STATE OF NORTH CAROLINA DEPARTMENT OF TRANSPORTATION

Request for Individual Permit Modification for NC 16 from north of SR 1386 in Lincoln County to North of SR 1895 in Catawba County. Federal Aid Project No. STP-F-24-1(34) State Project No. 8.1830501. \$475.00

Debit work order 34383.1.5. TIP Project No. R-2206B/C.

USACE Individual Permit dated October 7, 2004, Action ID 200420899.

RTMENT OF TRANSPORTAT		N SUBJECT		PROJECT [C-2206C	
DIVISION OF HIGHWAYS HIGHWAY BUILDING	PREPARED BY	DATE			
P. O. BOX 25201 EIGH. NORTH CAROLINA 2761	1 CHECKED BY	DATE	STR NO	SHEET C	
,	· _ ·		;		
		<u> </u>	:		
· · · · · ·		· · · · · · · ·

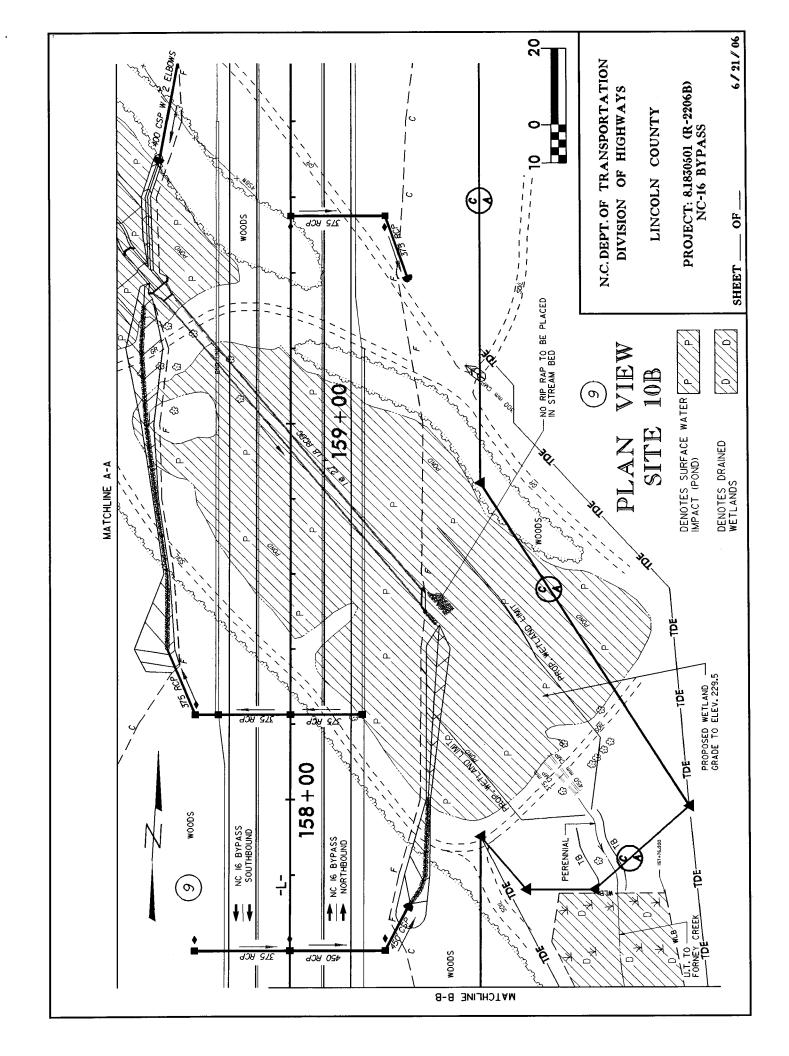
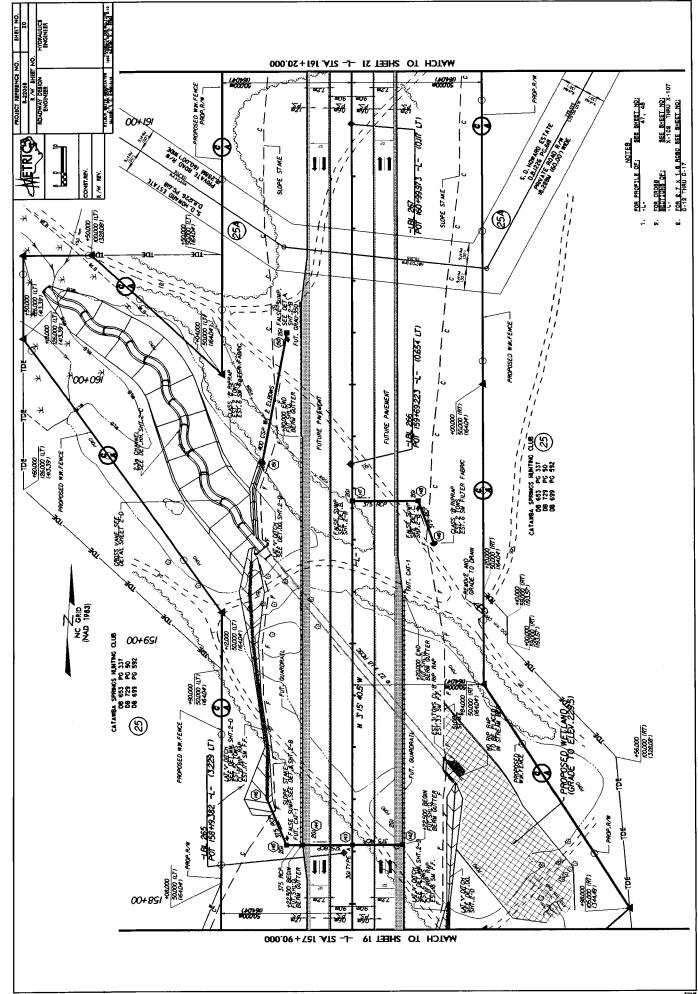
At this site NCDOT proposes to restructure part of the existing channel, repair the toe protection, create a floodplain bench, fill the old channel, and armor certain areas to the

water's edge. The impacts associated with these improvements were accounted for in the modification dated 7/26/06. Please refer to the permit drawing provided.

•			-;	. .	
		7 20 RA	P TOE PR	OTECTION	
			, <u></u> , , , , , , , , , , , , , , , , ,		
5 ⁻⁰					
- 1 - 1/		· · · · · · · · · · · · · · · · · · ·		L	
· · · · · · · · · · · · · · · · · · ·		: !			
XC.	7			Do	
<u> </u>		PAIR EXIST			
_ :		SHOWN OF			
·	$\Lambda \cap \Lambda = \Lambda$	BED RIP	EAP FOR	GRADE _	
	it con	TROL	· · · · · · · · · · · · · · · · · · ·	-

-	1 4-		,	
	1		<u>.</u> .		
EXCAVATE + Res	trudu R	1			
CHANNEL	- RC	K ARMOR	· -		
	0			•	
	i i	_ <u>i_</u>			
	VIII Ver	OLD CHANNEL	AREA TO	BE FILLE	
			XCAVATE		
EXCAVATE FOR		خصب ويعلم والمساحد المساعد ال		<i>y</i> • <i>w</i> ·	
FLOODPLAIN BEN	4 1/1/1	· · · · · · · · · · · · · · · · · · ·	· •••		
+ ARMOR W/			,		
		! !		-	
CLASS IF RIP R	z	ROCK, A	RMOR		
		10000	<u> </u>	<u> </u>	
	+!!			· - · · · ·	
		<u></u>	. 1 . 7	<u></u> .	
Dank MA For Nicks 7674 Da	te 6/2,100 pages 2		· · · ·
